Hydraulic Testing Summary Report Potrero Canyon Unit (Lockheed Martin Beaumont Site 1) Beaumont, California

Subject: Submittal of the Revised *Hydraulic Testing Summary Report, Potrero Canyon Unit (Lockheed Martin Beaumont Site 1), Beaumont, California*

HYDRAULIC TESTING SUMMARY REPORT, POTRERO CANYON UNIT, LOCKHEED
MARTIN CORPORATION, BEAUMONT SITE 1, BEAUMONT, CALIFORNIA (Site
Code: 400200)

Figure 3-5 – Drawdown versus Distance from BPA Pumping Well EW-20

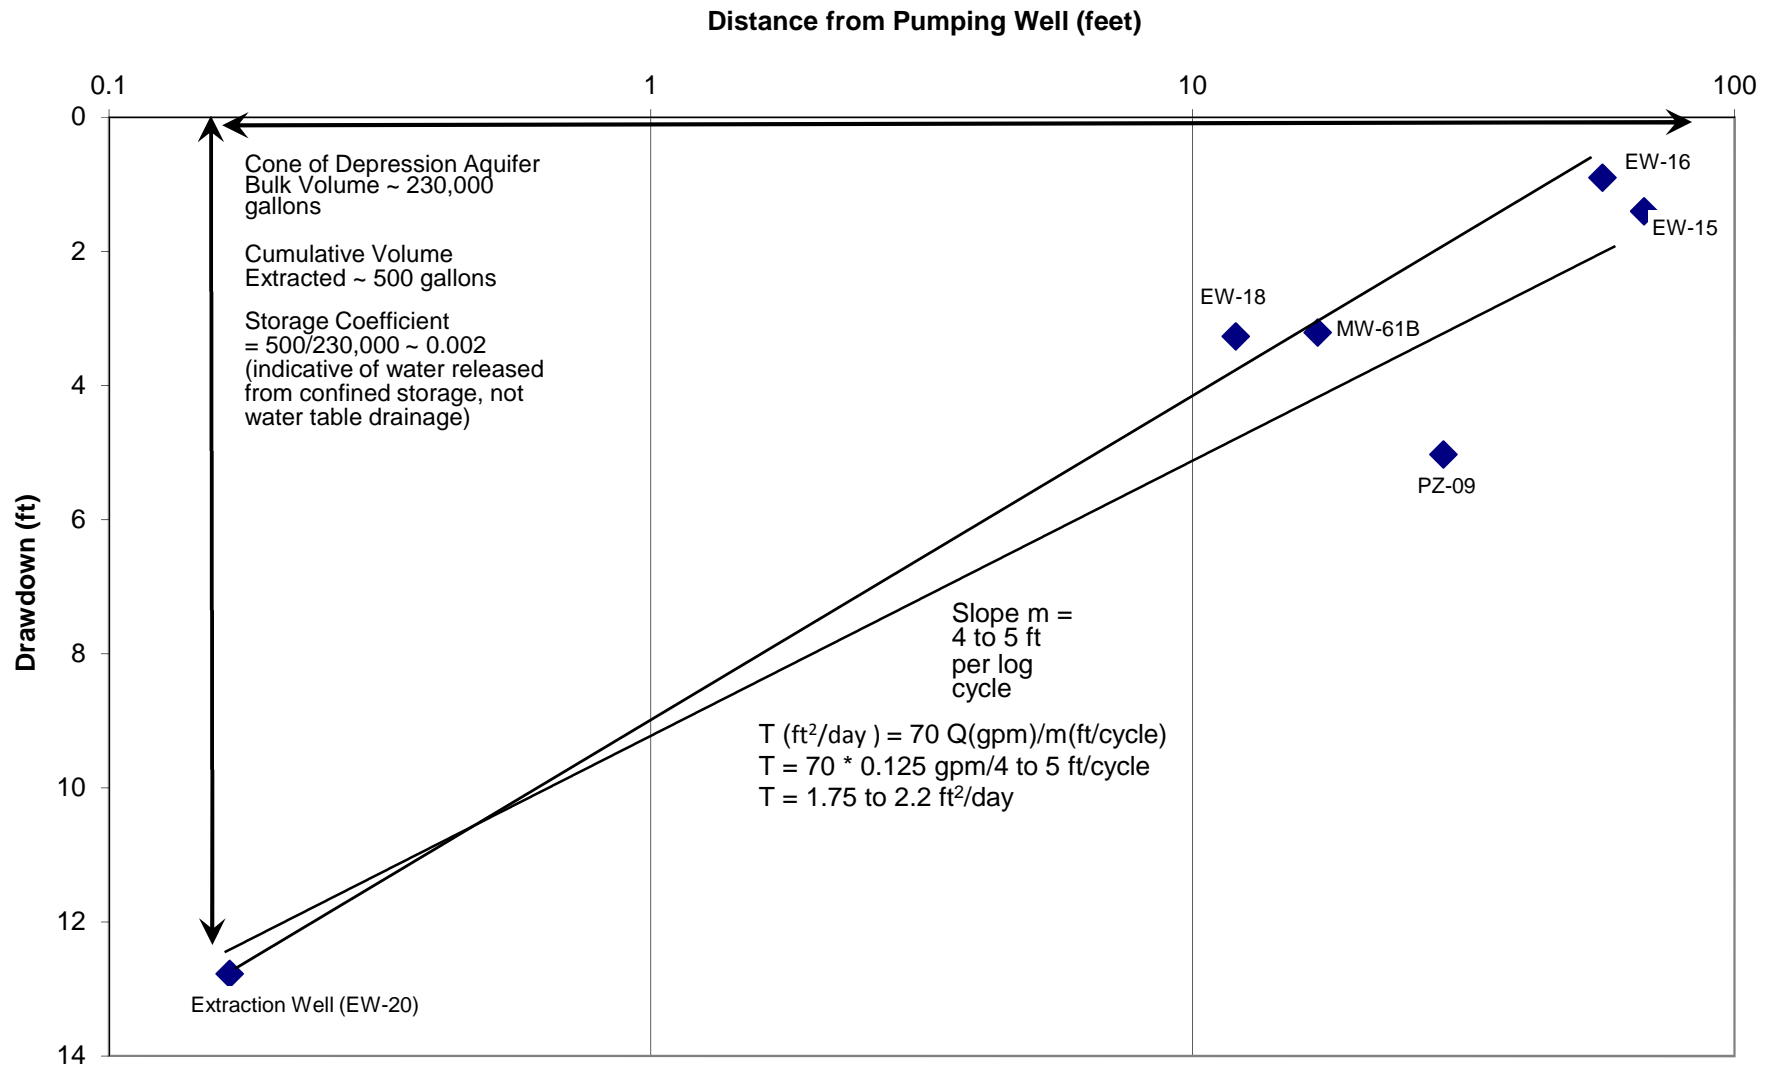
Please clarify why the assumed thickness of the aquifer is 37 feet when the boring logs do not indicate any lithologic or other changes at that depth.

Figure 3-8 Hydraulic Conductivity Profiles – Boreholes BH-1 and BH-2

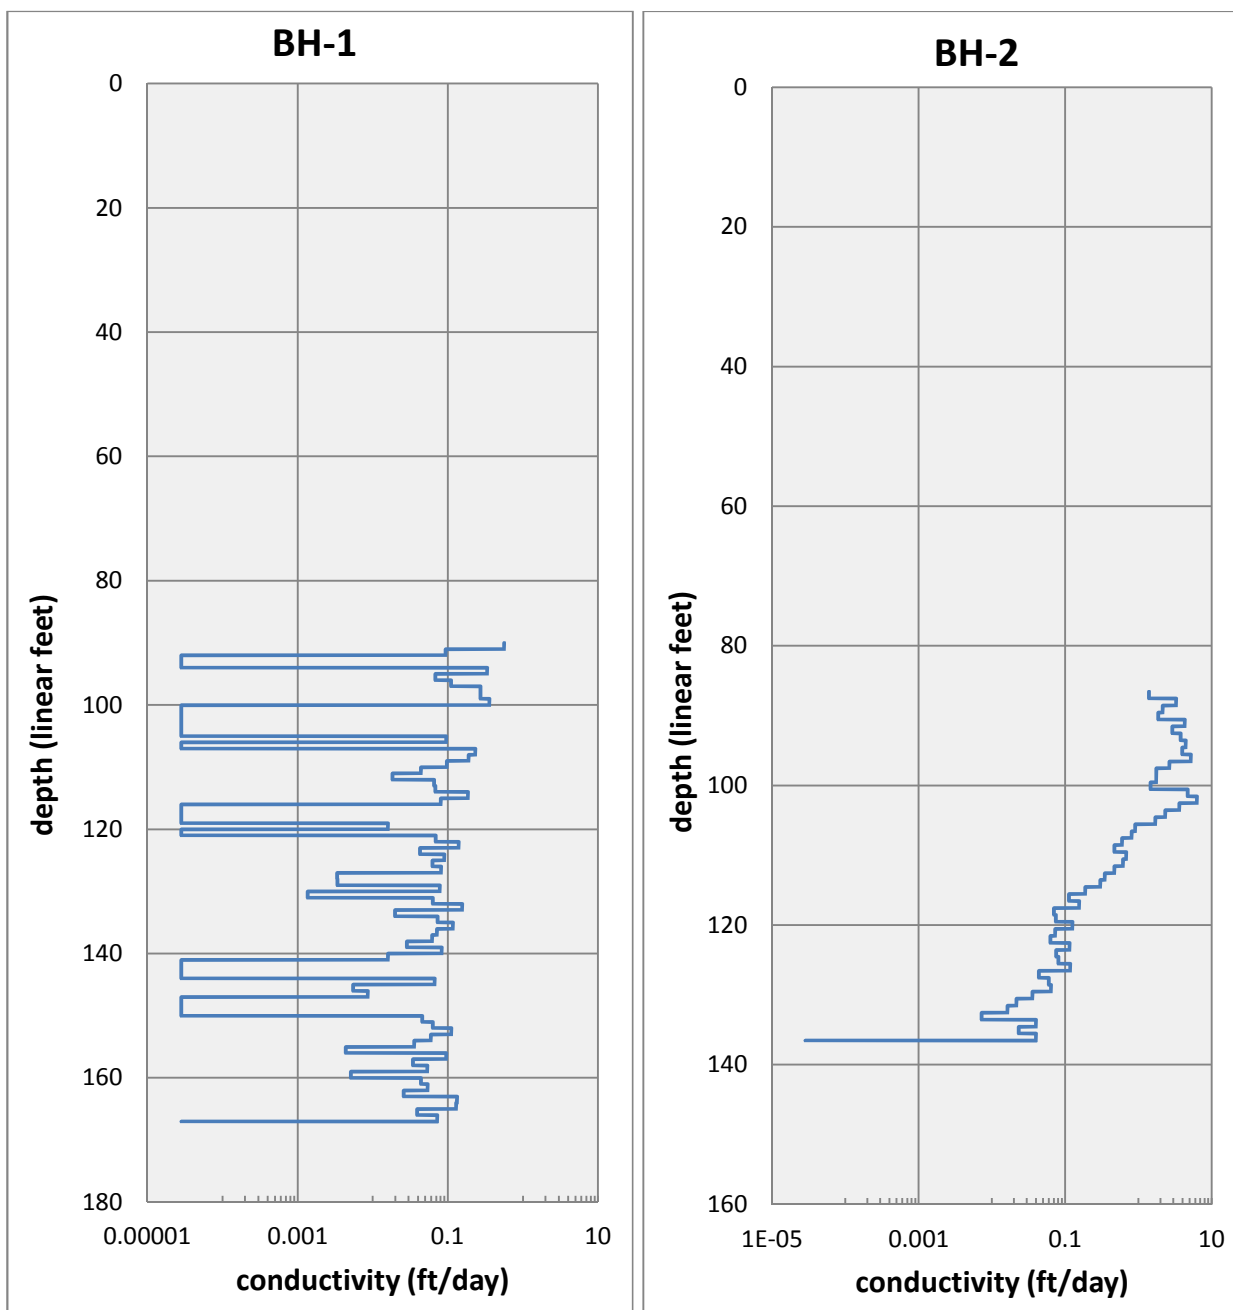
Specific Comments		
Comment	Response	Proposed Action
<p>site. The GSU would request clarification of these statements.</p>		
<p>17. 3.8.4 Hydraulic Conductivity Profiling Figure 3-8</p> <p>More variability is shown in the profile for BH-1. Were there any observations or data that may explain the differences between the two profiles (e.g., geophysical logs, laboratory tests, drilling rates, or boring logs)?</p>	<p>There were no differences observed in the cores, geophysical logs, or drilling rates to explain the greater variability in the BH-1 conductivity profile. No laboratory samples were collected from BH-2 to compare with BH-1. However, no large concentration swings were observed in the rock core analytical results for BH-1 which correspond with the observed conductivity changes.</p>	<p>No change to the document.</p> <p>No response needed.</p>
<p>18. Recommendations page 4-55</p> <p>The GSU would concur with the recommend that the CSM and groundwater flow and transport models be updated with the information from this report. The GSU, however, believe that additional work is needed as commented in this memorandum. Specifically, additional work is needed to understand the faults, fractures, buried stream drainage, and/or spatial variations in cementation that occur at the site at a scale sufficient to support the data needs of any Feasibility Study.</p> <p>The information presented in the report does not support that matrix diffusion has a significant effect at the site. The facility may consider conducting additional studies at the site to demonstrate its effect, if any. The GSU, however, believes that in the absence of a developed fracture system and due to the poorly-indurated nature of the</p>	<p>The CSM and groundwater flow and transport models are currently being updated based on the data collected during the hydraulic testing investigation. Flow and transport Model updates will include updating the hydraulic conductivity to be consistent with the test results in the BPA hot spot area, reevaluating the flow model water level calibration for the prior flow model calibration, reevaluating the transport model COC calibration for the prior transport model calibration, and updating the mass flux budgets. The model update will also include updating the flow and transport model stress periods and water level</p>	<p>DTSC will follow-up with further evaluation of the groundwater model which should be utilized to test the sensitivity of the nature and values assigned to the geologic structures at the site. The model should be used to assist in identifying parameters (i.e. hydraulic conductivity of the faults) that are not well constrained and, to which, the model is sensitive to.</p>

<p>17. 3.8.4 Hydraulic Conductivity Profiling Figure 3-8</p> <p>More variability is shown in the profile for BH-1. Were there any observations or data that may explain the differences between the two profiles (e.g., geophysical logs, laboratory tests, drilling rates, or</p>	<p>There were no differences observed in the cores, geophysical logs, or drilling rates to explain the greater variability in the BH-1 conductivity profile. No laboratory samples were collected from BH-2 to compare with BH-1. However, no large concentration</p>	<p>No change to the document.</p>
